Tesla, Inc. Service Bulletin		<h1>Replace HW4 Camera Hood</h1>	
SB-24-15-003 October 17, 2025		R2	
Classification Repair Bulletin		Section/Group 15 - Interior Trim	Mobile Service Can Perform (where permitted)
		Configuration HW4	
Model Model Y	Model Year 2024–2025	Country/Region Europe, Middle East, Africa	Build Location Giga Berlin
<small>The model(s) and model year(s) listed are a general approximation of the affected VIN list. Refer to the VIN/Bulletin Tracker or Customer/Vehicle profile to determine applicability of this bulletin for a particular vehicle.</small>

This Service Document supersedes SB-24-15-003 R1, dated August 1, 2025. This new revision, R2, updates the model years. Each content change is marked by a vertical line in the left margin. Discard the previous version and replace it with this one.

Figure 3

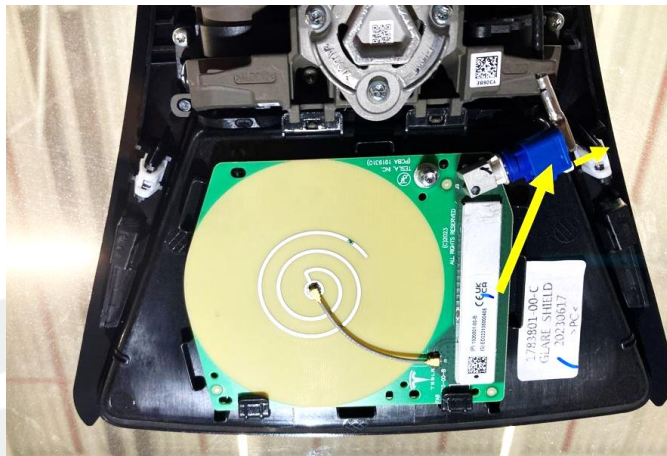
1. Remove the rear view mirror and both camera covers (refer to Service Manual procedure [15051802](#)).
2. Disconnect the GNSS antenna connector from the GNSS antenna (Figure 3).

Figure 4

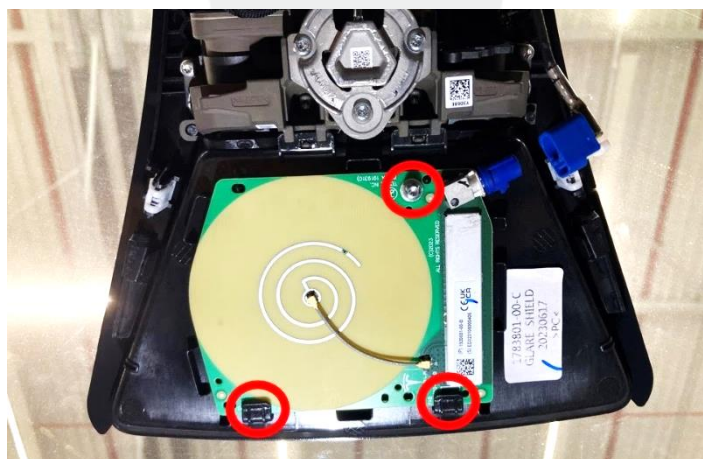
3. Remove the bolt (T10) that attaches the GNSS antenna to the camera hood, and then remove the GNSS antenna by pulling it backward from the tabs (x2) on the camera hood (Figure 4).

Figure 5 – Push side tabs (x2)

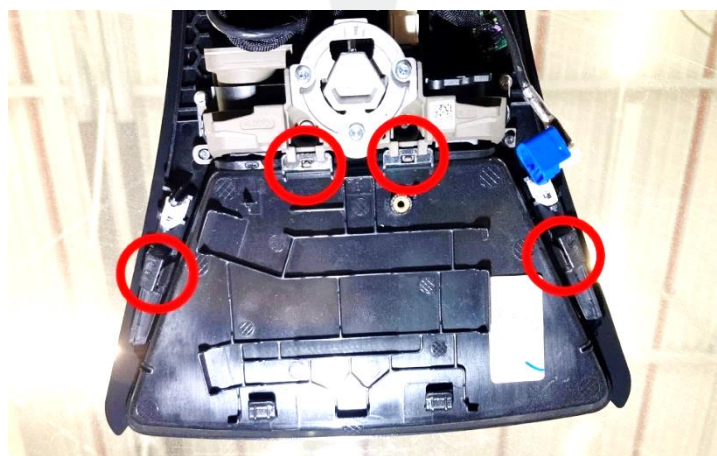
4. Push the tabs (x2) at the side of the camera hood, and then lower the camera hood from the tabs (x2) on the windshield bracket (Figure 5).

5. Attach the tabs (x2) at the top of the new camera hood to the camera assembly, and then engage the tabs (x2) at the side of the camera hood to install the camera hood to the windshield bracket (Figure 5).
6. Attach the GNSS antenna to the tabs (x2) of the camera hood, and then fasten the bolt (T10, torque 0.8 Nm) that attaches the GNSS antenna to the camera hood (Figure 4).
7. Connect the GNSS antenna connector to the GNSS antenna (Figure 3).
8. Install the upper camera cover, but do not install the rear view mirror and lower camera cover yet (refer to Service Manual procedure [15051802](#)).
